#### **Ordinance No. 2025-4838**

# Mayfair PD Rezone Economic Impact Analysis Planned Development Rezone PDR25-000002

Planned Development Rezone PDR25-000002

#### **RESPONSES TO PLANNING & ZONING COMPLIANCE REVIEW**

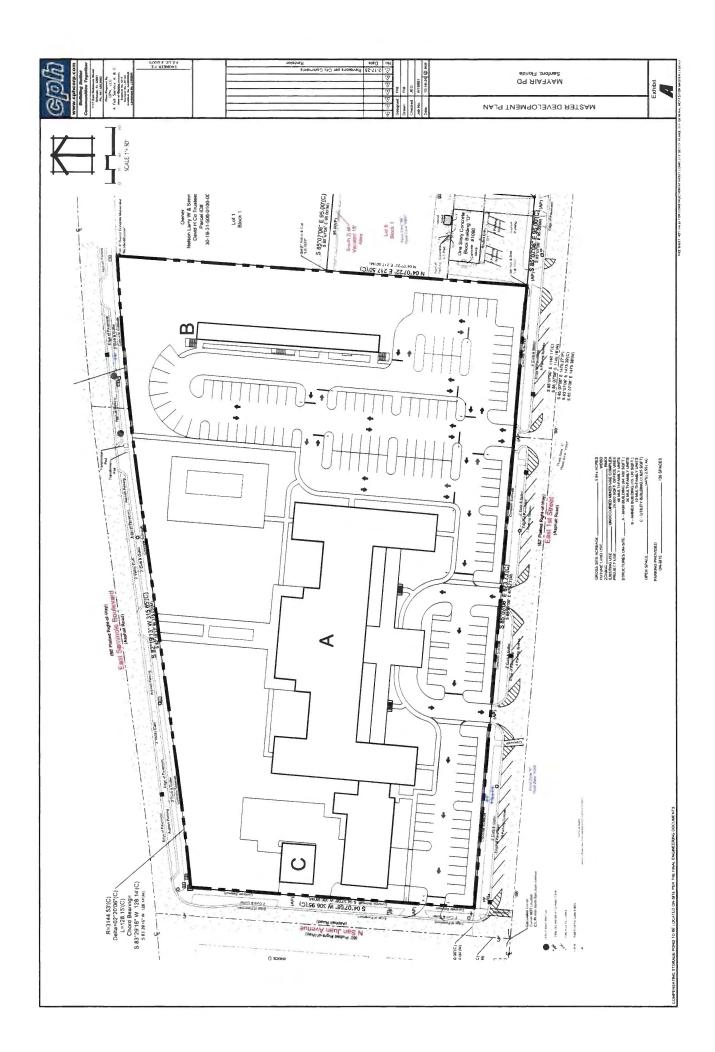
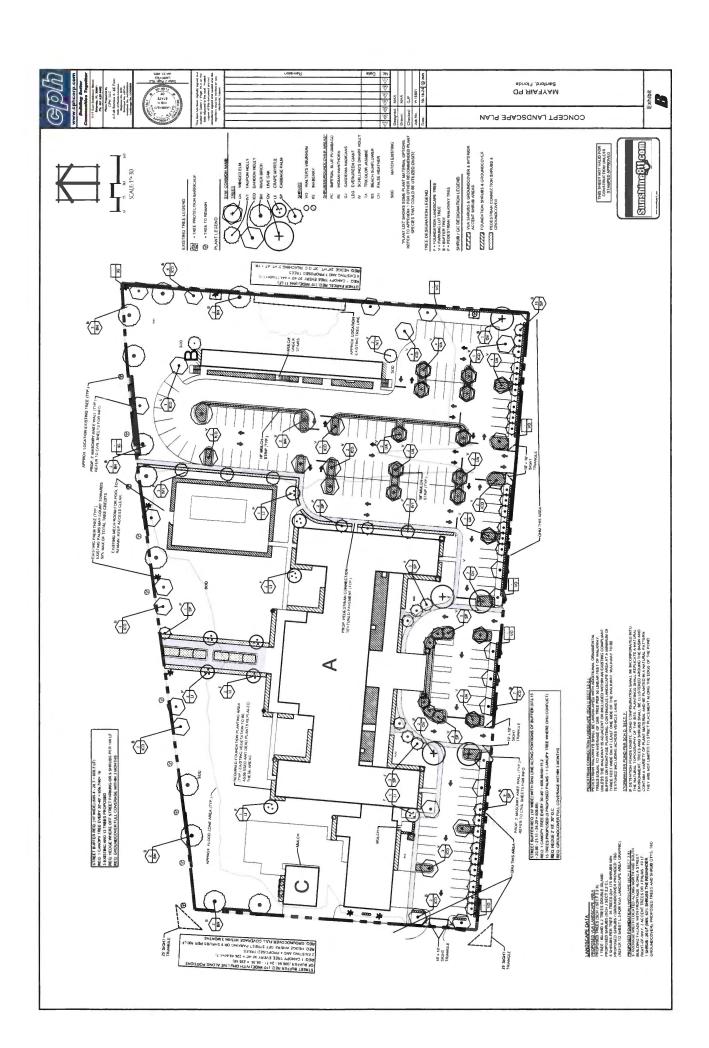
- Parking Lots containing more than thirty-six (36) parking stalls shall have clearly defined pedestrian connections provided between: a. A public right-of-way and building entrances b. Parking lots and building entrances 2. Pedestrian walkways shall be landscaped with additional shade or ornamental trees equal to an average of one (1) shade tree per fifty (50) linear feet of walkway, unless the walkway is adjacent or included within an existing compliant buffer or frontage planting. The walkway shall not be less than five (5) feet in width. 3. Pedestrian connections shall be clearly defined by at least two (2) of the following: a. Six (6) inch vertical curb. b. Textured paving, including across vehicular lanes. c. Continuous landscape area at

a minimum of three (3) feet wide on at least one (1) side of the walkway. d. One (1) shade tree shall be planted for each two-hundred (200) square feet of separate additional landscaped area.

- Palm Trees are not a compatible landscape trees. The trees need to be canopy trees along 1st Street and Seminole Blvd
- Standard buffers apply in addition to knee wall. See Schedule J
- · Provide open space calculations, FAR, and Density
- Along the pedestrian connection to the building from the waterfront the landscaping needs to be re-established.
- Any stormwater ponds need to landscaped in accordance with Schedule D (Recommend Cypress). Wet ponds require fountains
- Foundation Landscaping is required in accordance with Section 2.6 of Schedule J on th north and south facades.
- Missing CAPP meeting information, legal description

- PD Rezone Master Development Plan has been revised per City comments to depict a maximum of 135 spaces (Refer to Exhibit A).
- Refer to Exhibit A for knee wall along 1<sup>st</sup> Street and Seminole Boulevard. Knee wall details, materials, and placement to be included in Site Development Plan package.

- PD Rezone Master Development Plan (Exhibit A) and Landscape Plan (Exhibit B) have been revised to include:
  - A) Pedestrian connections between R/W and building entrances

- Open Space: 44% (2.55 AC±)
    - FAR: .37
    - Density: 7.9 DU/AC
  - E) Pedestrian connection from main structure to waterfront to be re-established (Refer to Exhibit B: Concept Landscape Plan)

- F) Stormwater pond(s)/area to be landscaped per Schedule D. Specific landscape plan to be included in Site Plan/civil engineering plan set based on final pond area configuration per St. Johns Water Management District permitting.

Landscape plan-specific adjustments (Refer to Exhibit B)

- Added knee wall as applicable
- Due to Overhead Utility (OHU) conflicts, palms have been added. Canopy trees have been added where no OHU conflicts exist.
- Added new planting areas along pedestrian connections.
